IFB NUMBER: IFB 22-073/JW
IFB TITLE: Main Terminal HVAC Rehabilitation at the Jack Brooks Regional Airport
IFB DUE BY: 11:00 AM CT, Wednesday, Friday, 15, 2023
ADDENDUM NO.: 1
ISSUED (DATE): January 31, 2023

Reason for Issuance of this Addendum: CLARIFICATIONS

Invitation for Bid (IFB 22-073/JW)
Main Terminal HVAC Rehabilitation at the Jack Brooks Regional Airport
ADDENDUM NO. 1

SHEET NUMBER
M2.03A
ROOF PLAN -
BID ALTERNATE
 22-413
 PROJECT NO.

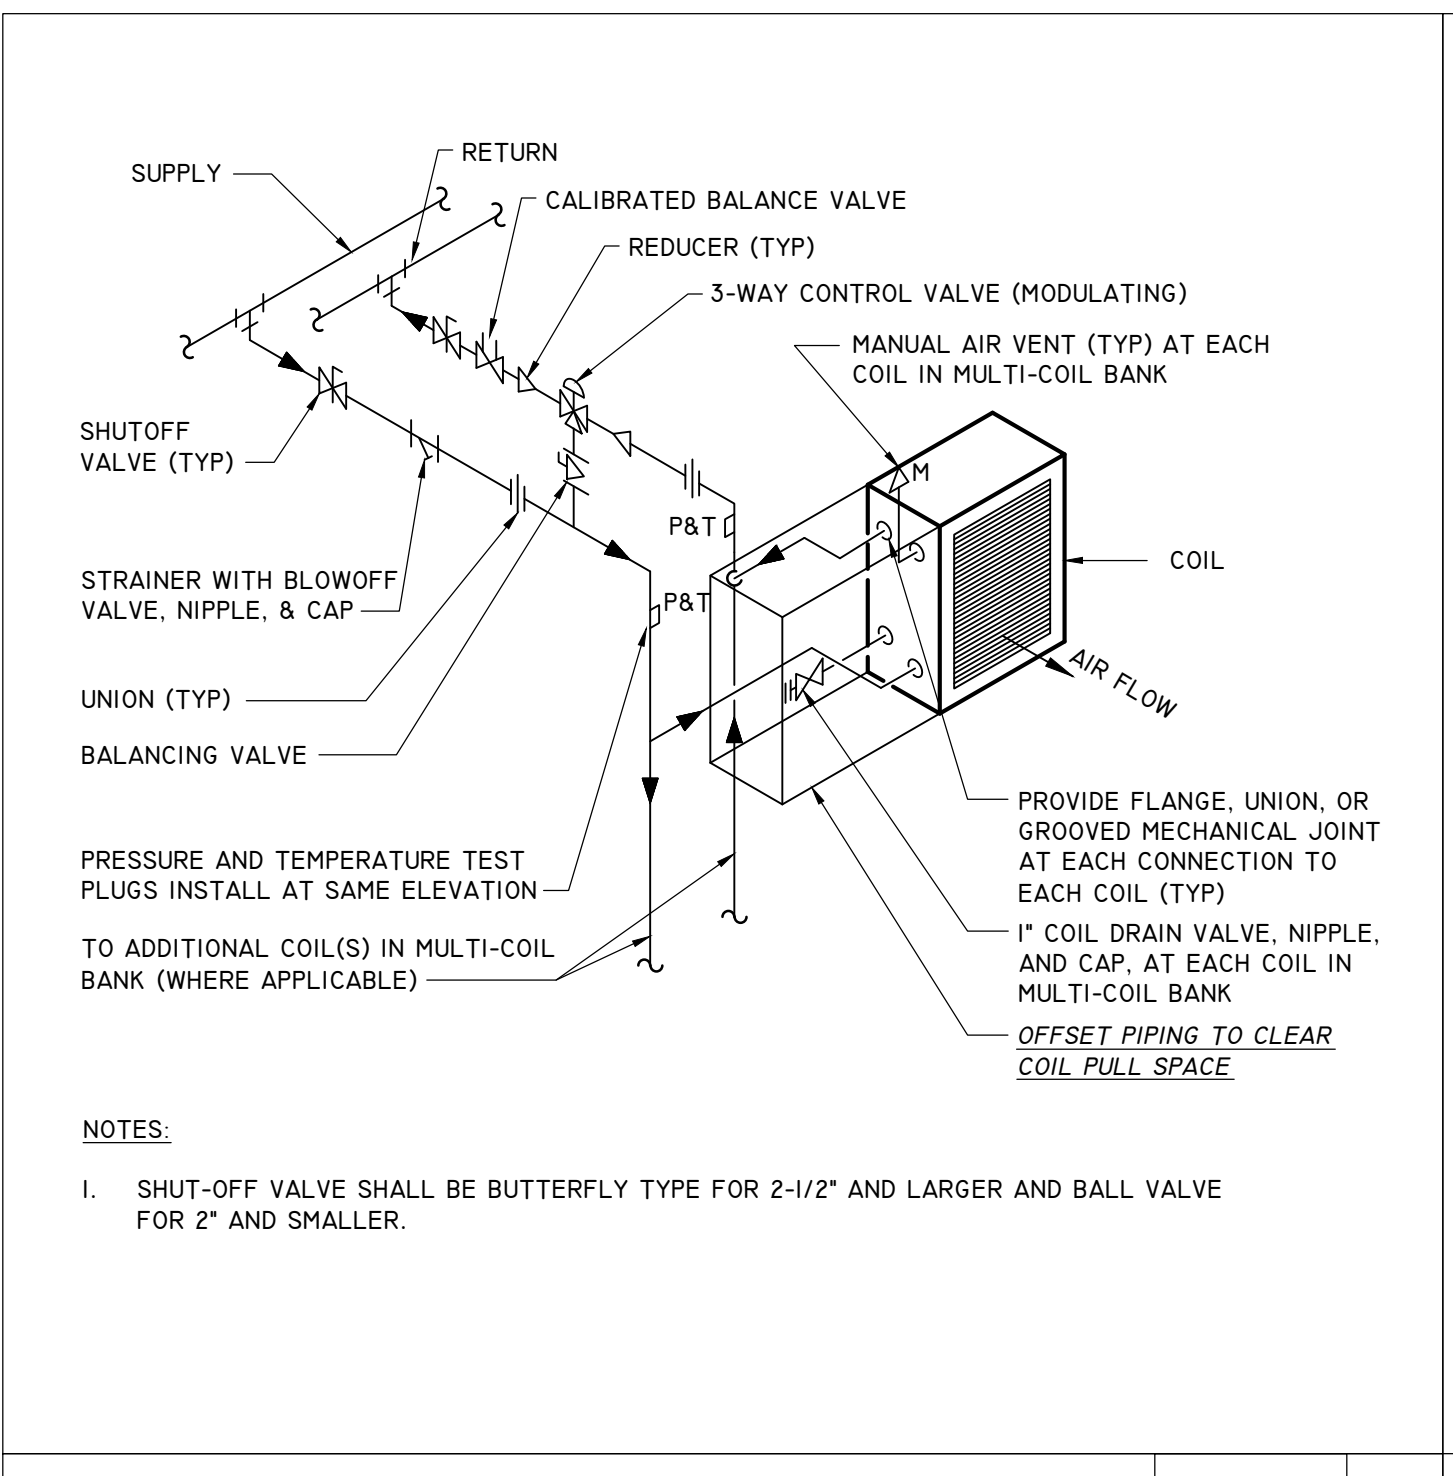
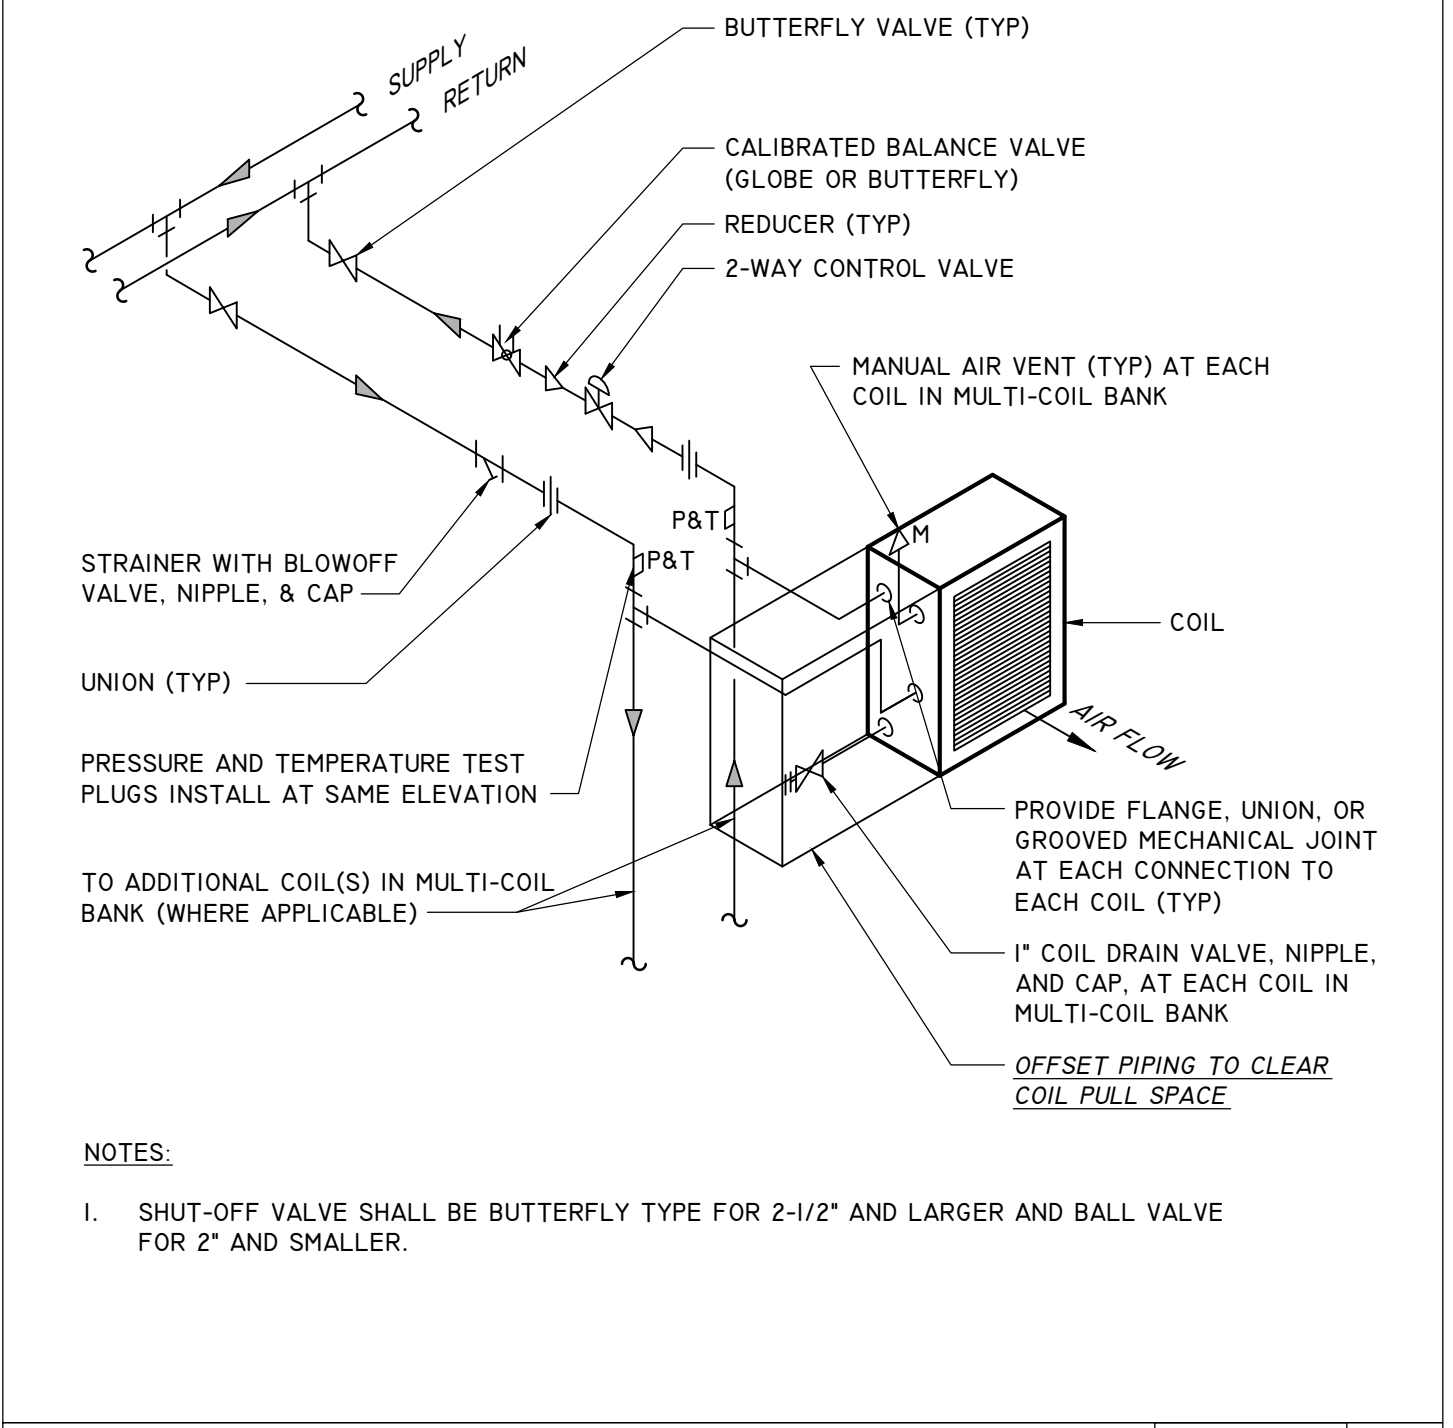
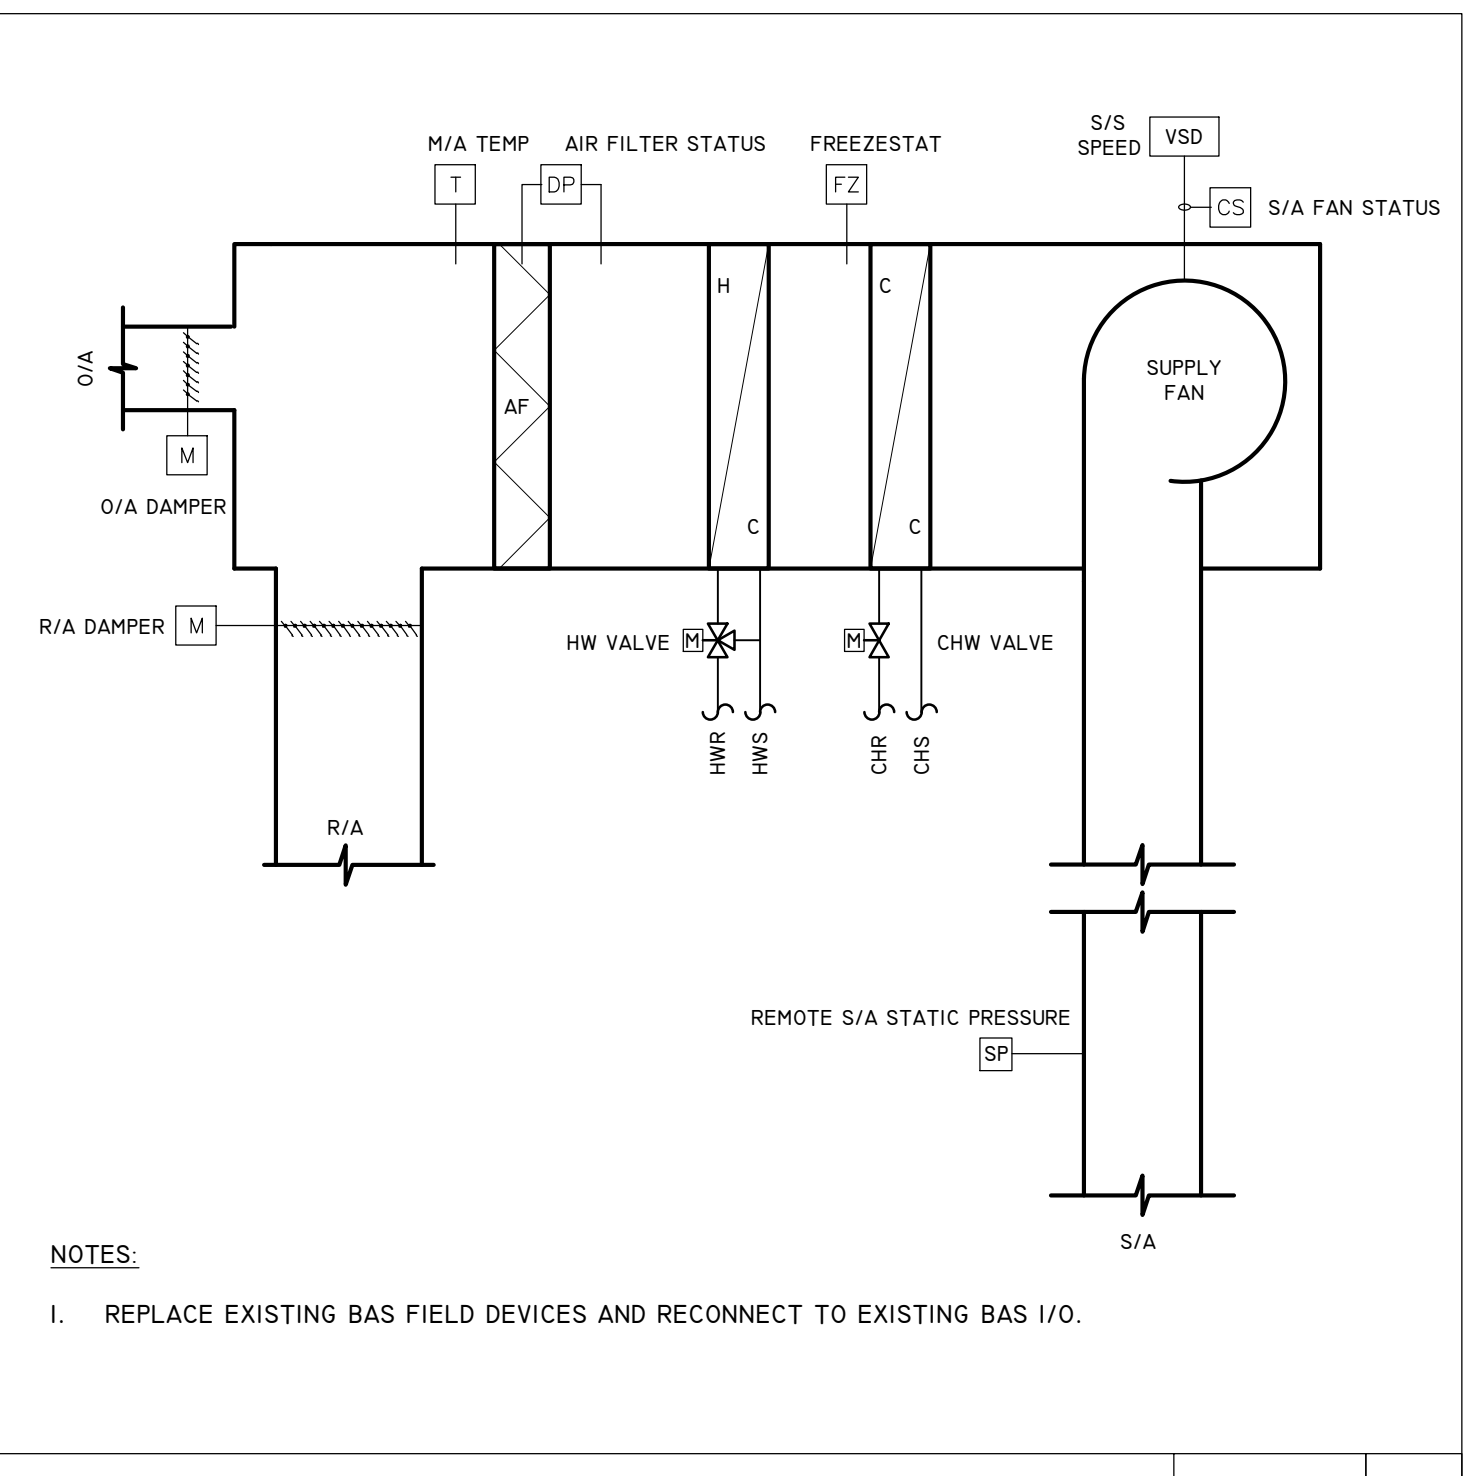
10. Enclosed you will find drawing M2.03A. Air handler units 1 – 7 are to be replaced per Alternate #1. (See Addendum No. 1: Attachment A)

KEYED NOTES:
 1. REPLACE AIR HANDLING UNIT AND ALL ASSOCIATED ACCESSORIES INCLUDING PIPING CONNECTIONS, ELECTRICAL AND CONTROLS. REFERENCE DETAILS.
